The study presents a new approach to assessing flood risk, based on monetary assessments of damage and exposed population, considering a more simplified modeling, which allows its application on a large scale. The main novelty of the study is accounting the uncertainties associated with the Manning roughness parameter (n). The approach is innovative and useful to assist in the decision-making process to increase the resilience of localities to floods. The results presented interesting inferences and discussions. I really enjoyed reading the text and learning about the methodology applied. Below, I present some considerations that can be incorporated into the text to deepen the discussion and some doubts that I hope will be better clarified.

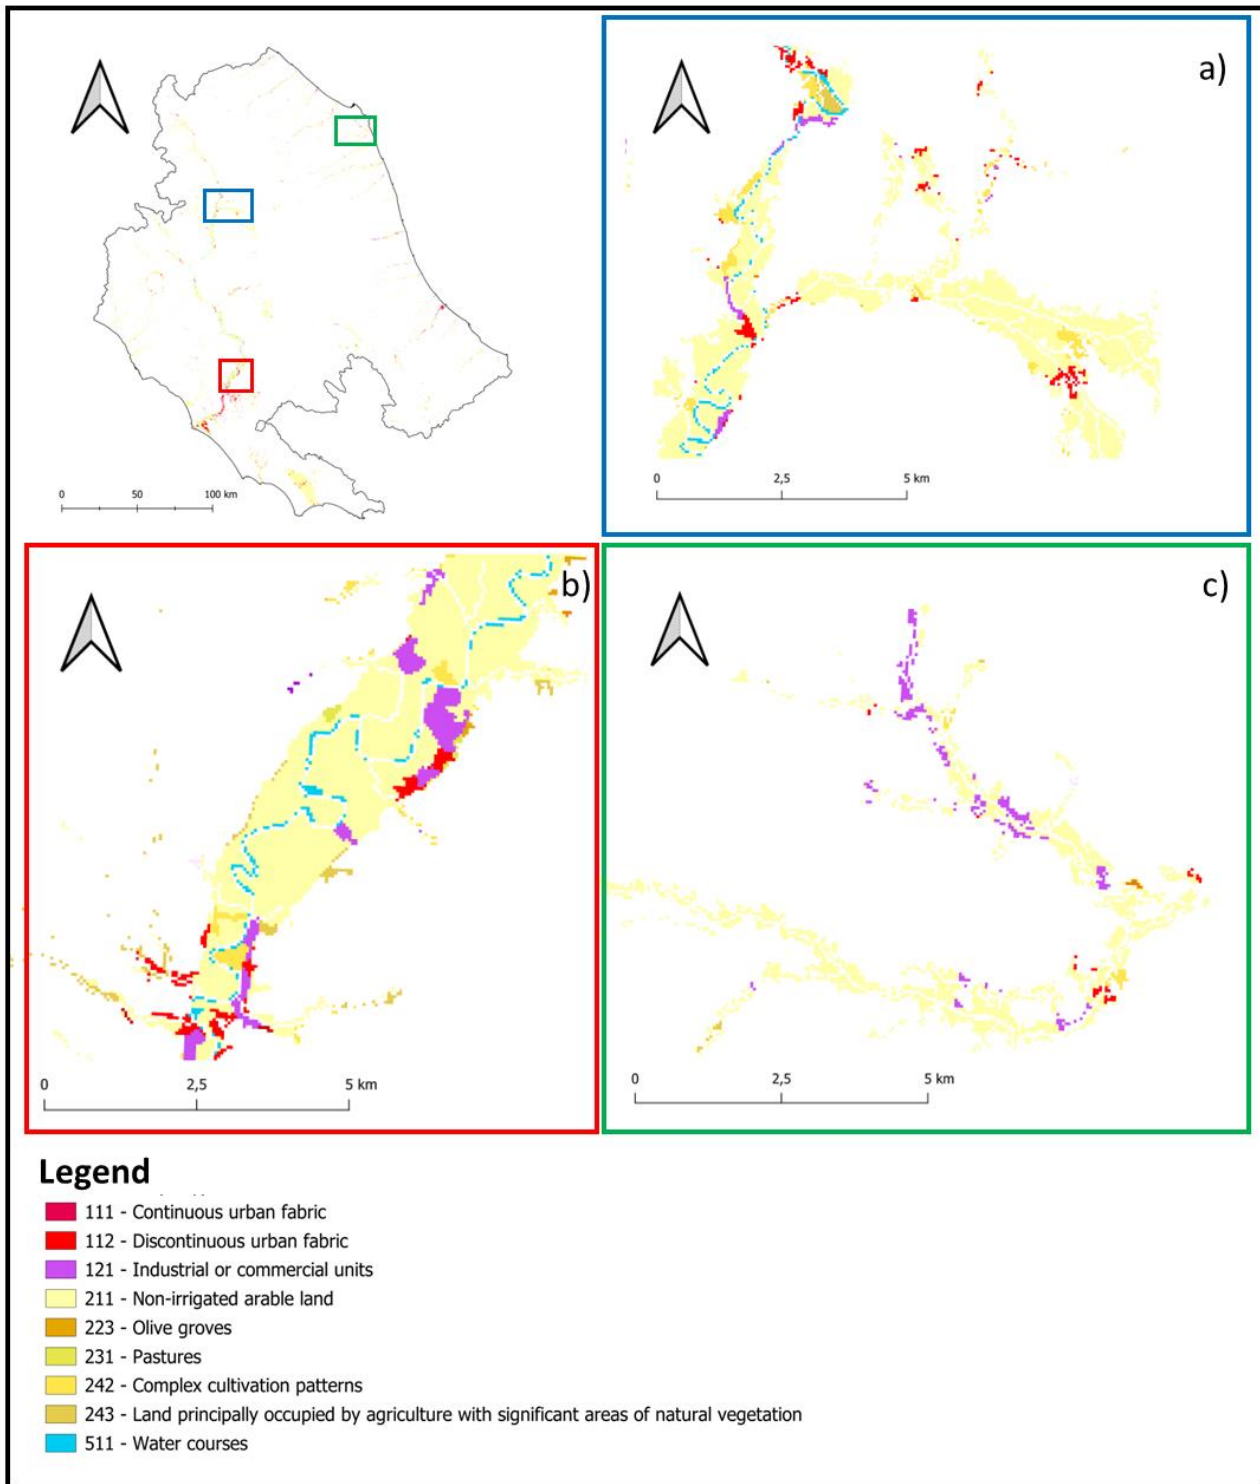
Either way, the authors provide many discussions in the next paragraphs in terms of LULC and the differences in the calculated maps and the ones obtained from PGRAAC. Therefore, I recommend including a figure of LULC in the study case section, to help the reader understand the discussions and draw their own conclusions.

Thank you for your suggestion. Following the style of Figure 2 this new Figure is proposed:
